December 22, 2021

Re: City of Palo Alto California Planning & Transportation Commission Special Meeting Agenda: December 15, 2021 – 985 Channing Avenue Application for a "Preliminary Parcel Map to Remove Recorded Height Restrictions on Underlying Parcel Map"

Document Filename: C1 985Channing PLANS.pdf Uploaded:08/24/20

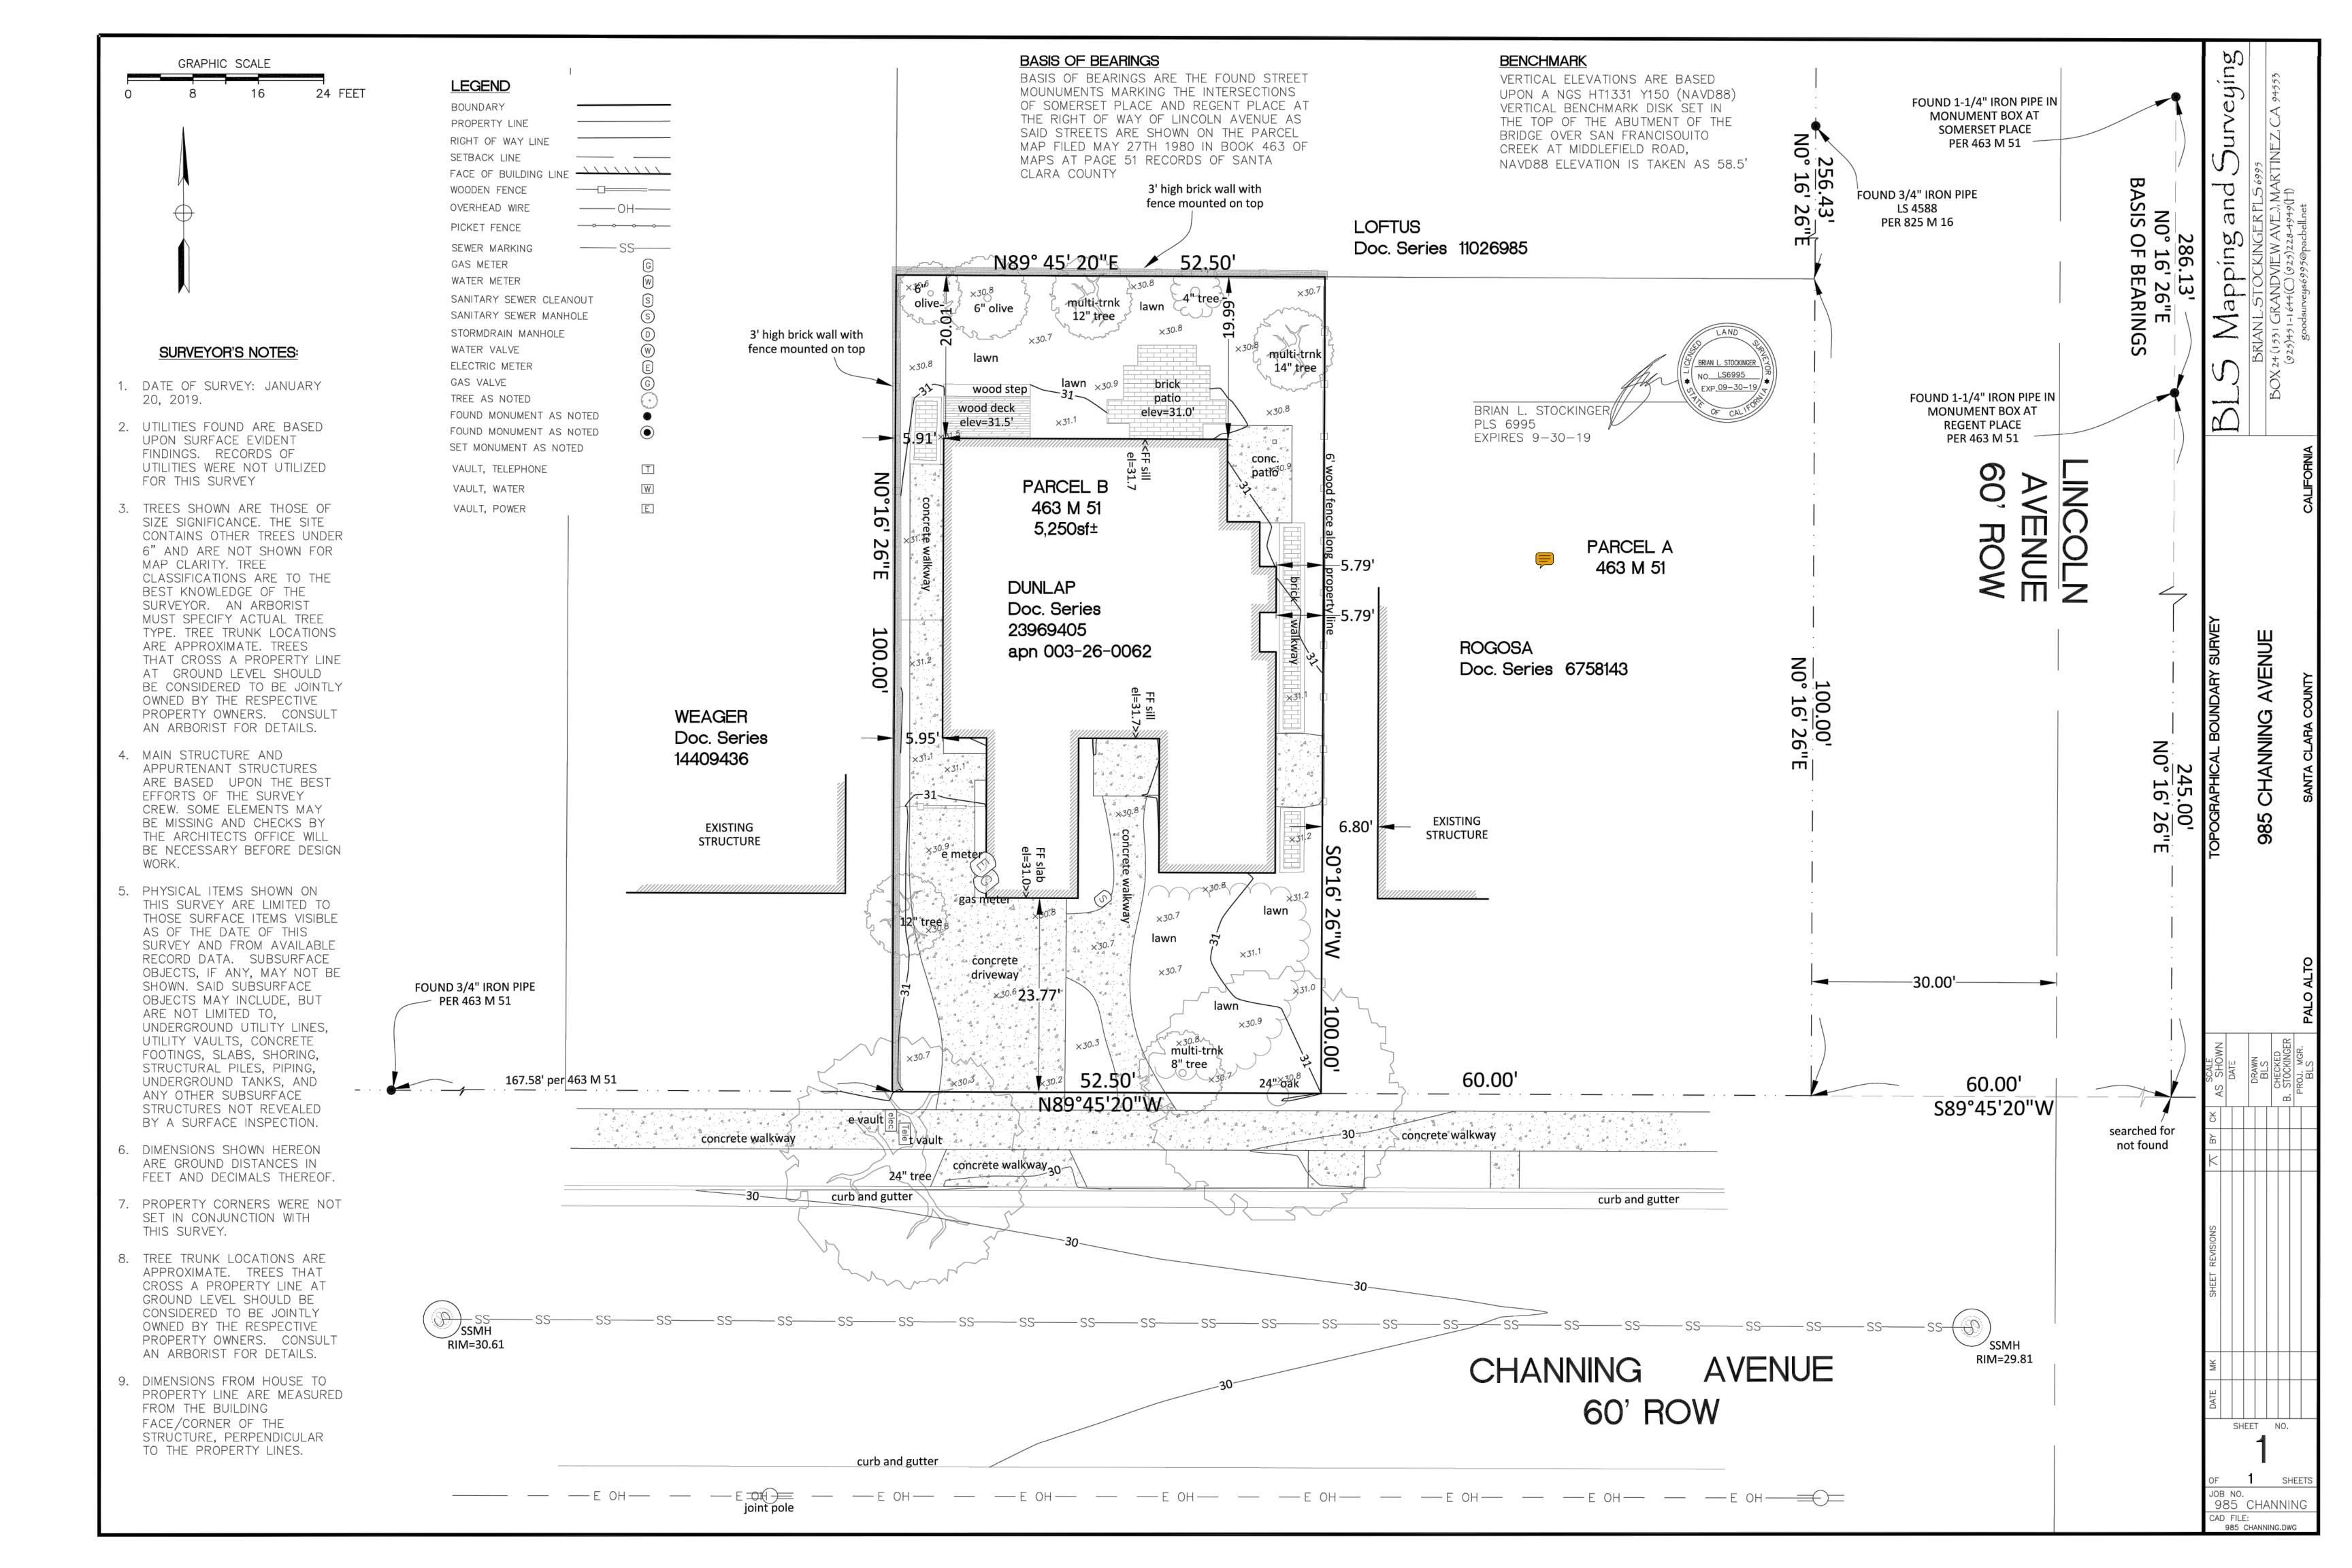
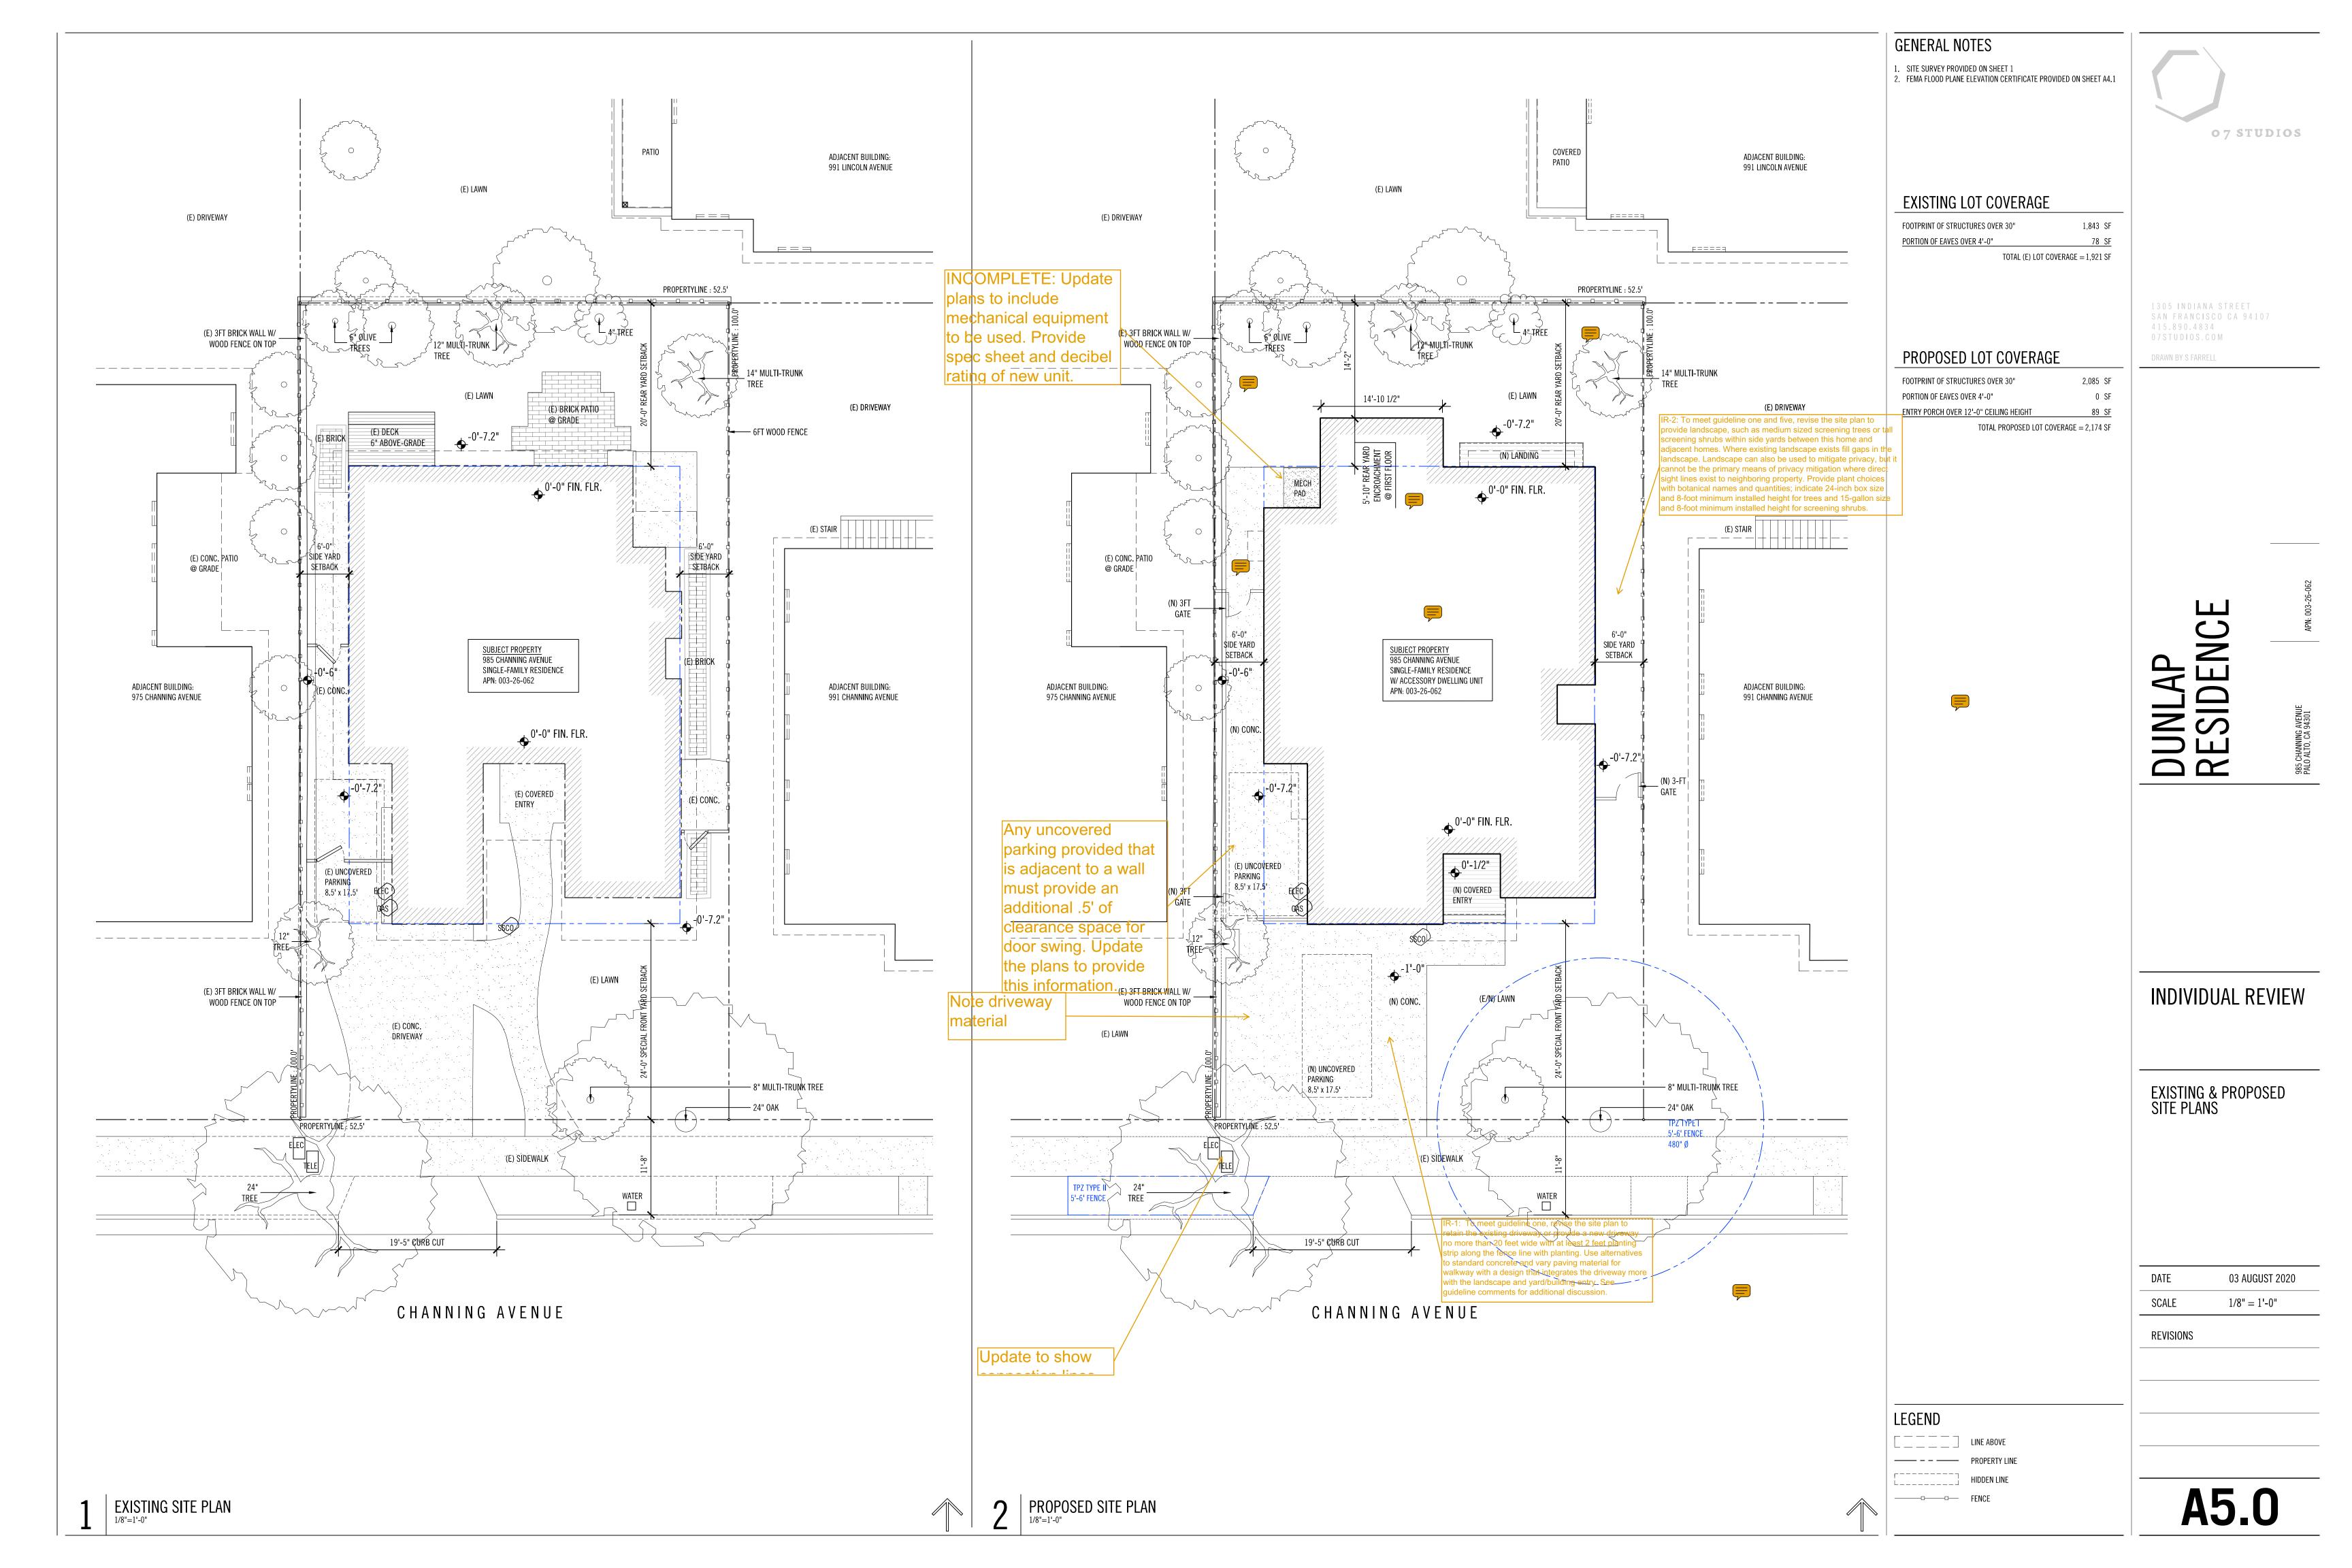
Page Reference	Annotation Type	Reviewer : Department	Review Comments
A1.0	Comment	Garrett Sauls□ : Planning	INCOMPLETE: Provide a signed copy of the Individual Review Statement of Understanding.
A1.0	Comment	Garrett Sauls□ : Planning	INCOMPLETE: Provide a contextual front yard setback diagram. See page 21 of the Zoning Technical Manual for an example of how to fulfil this requirement.

A1.0 Comment Garrett Sauls II : Planning allowance the state afforded as a bonus, but until, or if, that is approved, the plans will need to recognize this issue and the project data will need to be calculated towards that number. Any remaining square feet shall be used by the ADU up to 800 sq. fit to be exempted per state law. Update the plans to reflect this. A1.0 Comment Garrett Sauls II : Planning Garrett Sauls II : Planning Formation of the project data will be used by the ADU up to 800 sq. fit to be exempted per state law. Update the plans to reflect this. A3.0 Comment Garrett Sauls II : Planning Formation is project cannot be processed as it would violate those established conditions of approval to the applicant to provide direction on what next steps cold doctor. A3.0 Comment Garrett Sauls II : Planning Formation is project cannot be processed as it would violate those established conditions of approval. Staff has reached out to the applicant to provide direction on what next steps cold doctor. A3.0 Comment Garrett Sauls II : Planning Formation is provided information. A5.0 Callout Garrett Sauls II : Planning Formation is present. Update the source yard plans to include this information. A5.0 Callout Garrett Sauls II : Planning Formation is present. Update the source yard plans to include this information. A5.0 Callout Garrett Sauls II : Planning Formation is present. Update the source yard plans to include this information. A5.0 Comment Garrett Sauls II : Planning Formation is present. Update the source yard plans to include mechanical equipment to be used. Provide an additional. 5' of clearance space for doo swing. Update the plans to provide this information. A5.0 Comment Garrett Sauls II : Planning Formation is present. Update the source yard plans to include this information. A5.0 Comment Garrett Sauls II : Planning Formation is present. Update the source yard plans to address this issue. A5.0 Comment Garrett Sauls II : Planning Formation is present. Planning Formation is present. Planni	Page Reference	Annotation Type	Reviewer : Department	Review Comments

As.0 Comment Garrett Sauls D: Planning Per the IR Checklist, the survey must include information on the Base Flood Elevation required to meet FEMA shall D: Planning Per the IR Checklist, the survey must include information on the Base Flood Elevation required to meet FEMA shall D: Planning Per the IR Checklist, the survey must include information on the Base Flood Elevation required to meet FEMA shall D: Planning Per the IR Checklist, the survey must include information on the Base Flood Elevation required to meet FEMA shall D: Planning Per the IR Checklist, the survey must include information on the Base Flood Elevation required to meet FEMA shall D: Planning Per the IR Checklist, the survey must include information on the Base Flood Elevation required to meet FEMA shall D: Planning Per the IR Checklist, the survey must include information on the Base Flood Elevation required to meet FEMA shall D: Planning Per the IR Checklist, the survey must include information on the Base Flood Elevation required to meet FEMA shall D: Planning Per the IR Checklist, the survey must include information on the Base Flood Elevation required to meet FEMA shall D: Planning Per the IR Checklist, the survey must include information on the Base Flood Elevation required to meet FEMA shall D: Planning Per the IR Checklist the survey must include information on the Base Flood Elevation required to meet FEMA shall D: Planning Per the IR Checklist Ped Per	A1.0	Comment	Garrett Sauls□ : Planning	necessary to building an 800 sq ft unit as well as the total property's FAR. Currently, this square footage cannot be recaptured in a subsequent application. Staff is proposing to bring a new ordinance to Council that would treat the allowance the state afforded as a bonus, but until, or if, that is approved, the plans will need to recognize this issue and the project data will need to be clarified. Currently, only 2,292 FAR on the property is being used by the home when the existing garage needs to be calculated towards that number. Any remaining square feet shall be used by

A4.0 Comment Garrett Sauls : Planning Sarrett	A1.0	Comment	Garrett Sauls□ : Planning	Due to a previously approved Subdivision for the Parcel from 1980, City Council established conditions of approval recorded against 985 Channing Avenue that limited the height of the structure to 13 feet and one-story tall. As such, this project cannot be processed as it would violate those established conditions of approval. Staff has reached out to the applicant to provide direction on what next steps could occur.
As.0 Callout Garrett Sauls : Planning Standards. It is unclear if this information is present. Update the survey and plans to include this information. As.0 Callout Garrett Sauls : Planning November 1 Planning November 1 Planning November 2 Plan	A3.0	Comment	Garrett Sauls□ : Planning	New fences that are shown to be in disrepair or overhanging on adjacent properties must be replaced. Update the plans to show a new fence will replace the existing one.

A5.0 Callout Garrett Sauls 1: Planning INCOMPLETE: Update plans to provide this information. A5.0 Callout Garrett Sauls 1: Planning INCOMPLETE: Update plans to include mechanical equipment to be used. Provide spec sheet and decibel rating of new unit. A5.0 Callout Garrett Sauls 1: Planning Note driveway material A5.0 Callout Garrett Sauls 1: Planning Update to show connection lines to house and any proposed utility connections (such as gas or other). A5.0 Comment Garrett Sauls 1: Planning Per PAMC 18.54, maximum residential driveway widths are 20 feet. Reduce the driveway paving to comply with this requirement. A5.0 Comment Garrett Sauls 1: Planning INCOMPLETE: Show footprints and overhangs of all existing and proposed buildings. Per PAMC 18.40.070, encroachments, including eaves of buildings, are not allowed within the special setback for the building. Update the plans to address this issue. A5.0 Comment Garrett Sauls 1: Planning All trees to remain must have tree protection fencing provided for them. Update the plans to show this information the plans, including those that overhang the site. Update the plans to correct this. A5.0 Comment Garrett Sauls 1: Planning Garr	A4.0	Comment	Garrett Sauls□ : Planning	Per the IR checklist, the survey must include information on the Base Flood Elevation required to meet FEMA standards. It is unclear if this information is present. Update the survey and plans to include this information.

A5.0 Callout Garrett Sauls : Planning Note driveway material A5.0 Callout Garrett Sauls : Planning Vipdate to show connection lines to house and any proposed utility connections (such as gas or other). A5.0 Comment Garrett Sauls : Planning Per PAMC 18.54, maximum residential driveway widths are 20 feet. Reduce the driveway paving to comply with this requirement. A5.0 Comment Garrett Sauls : Planning NCOMPLETE: Show footprints and overhangs of all existing and proposed buildings. Per PAMC 18.40.070, encroachments, including eaves of buildings, are not allowed within the special setback for the building. Update the plans to address this issue. A5.0 Comment Garrett Sauls : Planning All trees to remain must have tree protection fencing provided for them. Update the plans to show this information The IR checklist requires that all trees species be identified on the plans, including those that overhang the site. Update the plans to correct this. A5.0 Comment Garrett Sauls : Planning NoCOMPLETE: Topographic elevation of the first floor level and spot elevations of existing and finished grade around property to determine daylight plane compliance and adjacent to building footprint for height measurement. See pages 26-28 of the Zoning Technical Manual. Additionally, the points provided around the site inaccurately reflect actual topographical elevations from the survey. Correct these. A5.0 Comment Garrett Sauls : Planning Additional screening trees may be required along the left and rear sides of the property to conform with the IR didelines. Update plans following recommendations for IR Guidelines. A6.1 Comment Garrett Sauls : Planning Provide a calculation that identifies at least 60% permeability within the front yard setback. This house is effectively a brand new structure. Any existing non-conforming walls must be replaced in a conforming condition per 18.70.100. In order to support the proposed additions what walls are claimed to "remain will ultimately be modified to an extent that they are new. A6.2 Comm	A5.0	Callout	Garrett Sauls□ : Planning	Any uncovered parking provided that is adjacent to a wall must provide an additional .5' of clearance space for door swing. Update the plans to provide this information.

A5.0 Callout Garrett Sauls Planning Comment Garrett Sauls Planning Per PAMC 18.54, maximum residential driveway widths are 20 feet. Reduce the driveway paving to comply with this requirement. A5.0 Comment Garrett Sauls Planning Garrett Sauls Planning Per PAMC 18.54, maximum residential driveway widths are 20 feet. Reduce the driveway paving to comply with this requirement. A5.0 Comment Garrett Sauls Planning Garrett Sauls Planning Garrett Sauls Planning National State Planning Garrett Sauls Planning Garrett Gauls Plannin	A5.0	Callout	Garrett Sauls□ : Planning	INCOMPLETE: Update plans to include mechanical equipment to be used. Provide spec sheet and decibel rating of new unit.
A5.0 Comment Garrett Sauls Planning Per PAMC 18.54, maximum residential driveway widths are 20 feet. Reduce the driveway paving to comply with this requirement. A5.0 Comment Garrett Sauls Planning Garrett Sauls Planning Planning All trees to remain must have tree protection fencing provided for them. Update the plans to show this information The IR checklist requires that all trees species be identified on the plans, including those that overhang the site. Update the plans to correct this. A5.0 Comment Garrett Sauls Planning Garrett Sauls Planning Garrett Sauls Planning The IR checklist requires that all trees species be identified on the plans, including those that overhang the site. Update the plans to correct this. A5.0 Comment Garrett Sauls Planning INCOMPLETE: Topographic elevation of the first floor level and spot elevations of existing and finished grade around property to determine daylight plane compliance and adjacent to building footprint for height measurement. See pages 26-28 of the Zoning Technical Manual. Additionally, the points provided around the site inaccurately reflect actual topographical elevations from the survey. Correct these. A5.0 Comment Garrett Sauls Planning Additional screening trees may be required along the left and rear sides of the property to conform with the IR Guidelines. Update plans following recommendations for IR Guidelines. A6.1 Comment Garrett Sauls Planning Provide a calculation that identifies at least 60% permeability within the front yard setback. This house is effectively a brand new structure. Any existing non-conforming walls must be replaced in a conforming condition per 18,010.0 in order to support the proposed additions what walls are claimed to "remain will ultimately be modified to an extent that they are new. A6.2 Comment Garrett Sauls Planning Update FAR diagram to provide dimensions for each area. A7.1 Comment Garrett Sauls Planning Update FAR diagram to provide dimensions for each area.	A5.0	Callout	Garrett Sauls : Planning	Note driveway material
